Proposal for amendments to ECE/TRANS/WP.29/GRVA/2019/19

This document proposes amendments to ACSF of Category B1

Intermediate system acc. to ISO 8855:2011 Vehicle system acc. to ISO 8855:2011

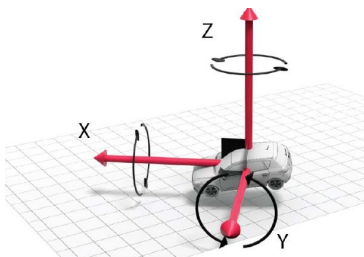
B. paragraph 2.4 – coordinate system

The vehicle coordinate system according to ISO 8855:2011 describes a coordinate system where the x and y axes are fixed to the vehicle, so when the vehicle rolls, the gravitation will have an effect on the vehicle's lateral acceleration. Since the aim of this paragraph is to remove external influences, the intermediate coordinate system according to ISO 8855:2011 should be referenced instead, where the x and y axes always remain parallel to the ground plane.

The lateral acceleration data at the vehicle center of gravity shall be determined by removing additional effects due to the movements of the vehicle body (e.g. roll of sprung mass) and by correcting for sensor placement via the use of coordinate transformation. As reference, the **intermediate axis vehicle-coordinate system as described in ISO 8855:2011 shall be used."**
